TENNESSEE VALLEY AUTHORITY

Enclosed is Revision 3 of TVA's response to the Auxiliary Systems Branch (ASB) fire protection review questions for the Sequoyah Nuclear Plant. This information was requested in your letter to N. B. Hughes dated September 1, 1978. The original information, Revision 1 and Revision 2, was submitted by my letters to you dated November 9, 1978, December 19, 1978, and January 19, 1979, respectively. This revision includes:

AUXILIARY SYSTEMS BRANCH  
FIRE PROTECTION REVIEW  
SEQUOYAH NUCLEAR PLANT - UNITS 1 AND 2  
DOCKET NUMBERS 50-327/328

FIGURE 7-2

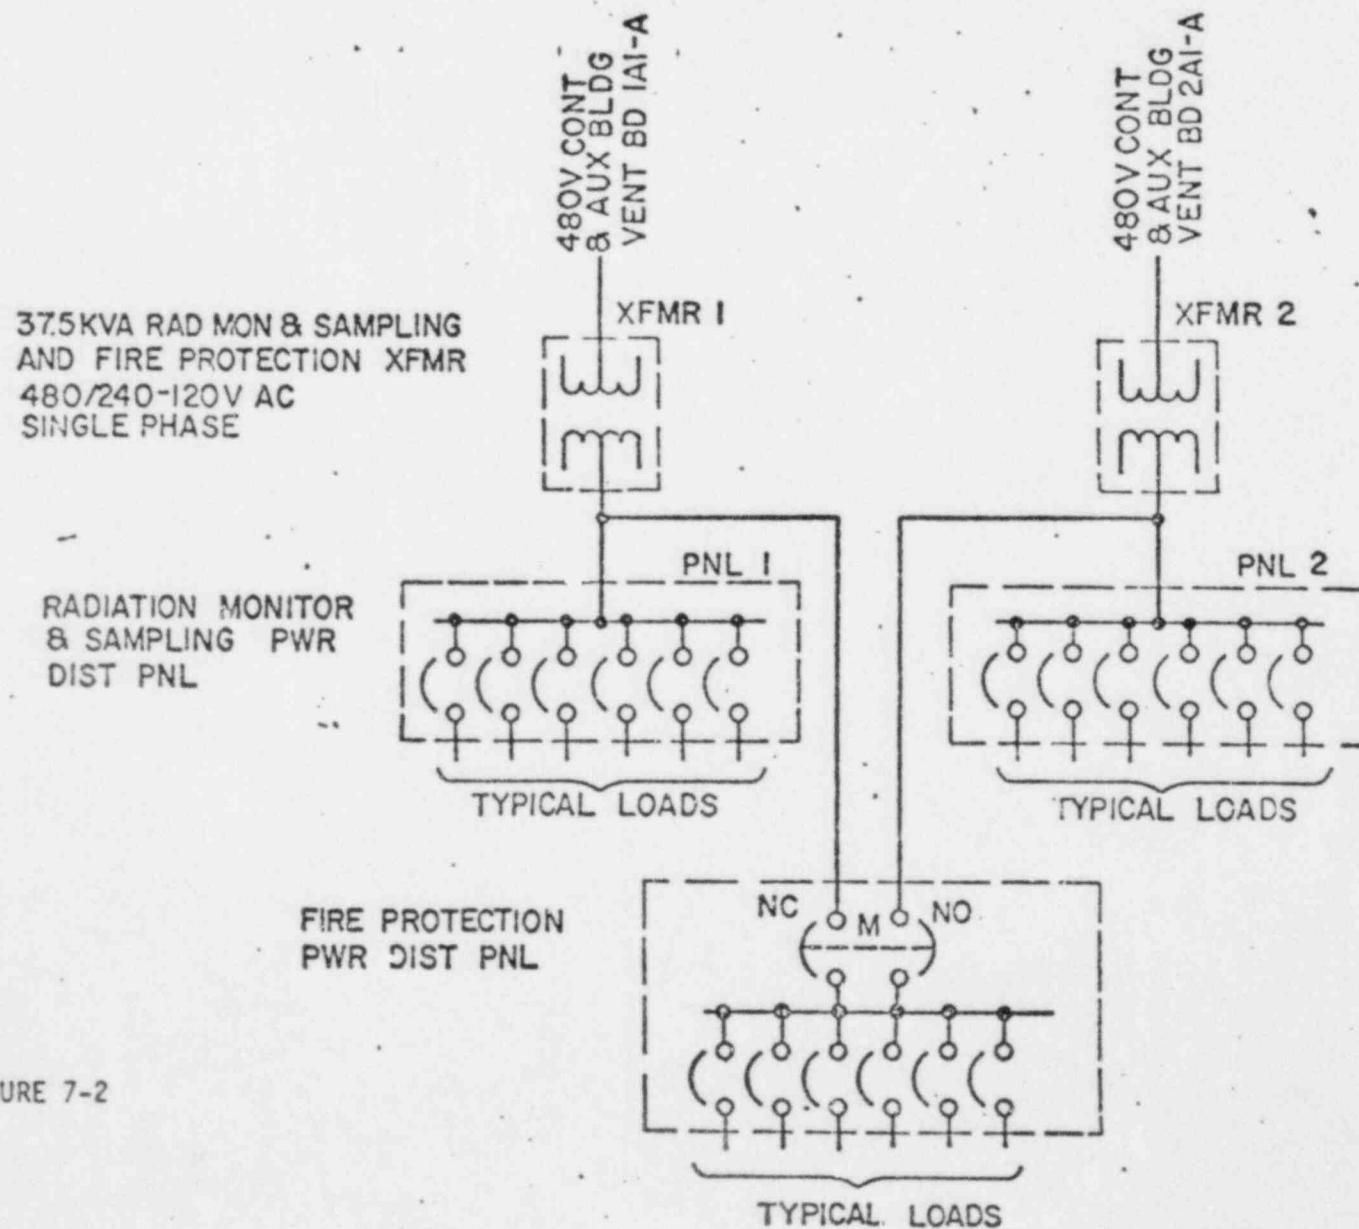
7. Item E.1, Fire Detection - Your description of the fire detection system is incomplete. Describe the type of detector provided for each room or area containing safety related equipment or systems. Also, provide a detailed description of the fire detection system, supported where necessary, by diagrams or appropriate prints (include a single line drawing from the detection circuits, waterflow alarms, through the subpanels and into the control room).

The fire detection system is powered from a single 120V ac distribution panel as shown in Figure 7-2. The panel is provided with a manual transfer switch to allow normal or alternate power feed from 480V ac control and auxiliary building ventilation boards 1A1-A and 2A1-A, respectively. Both ventilation boards are automatically connected after 10 seconds to the emergency diesel generators on loss of offsite power. The system's power supply complies with the applicable guidelines in Regulatory Guides 1.6 and 1.32 and partially complies with Regulatory Guide 1.75 as discussed in FSAR section 8.3. The fire protection power distribution panel will be electrically supervised to provide an alarm in the main control room upon loss of power.
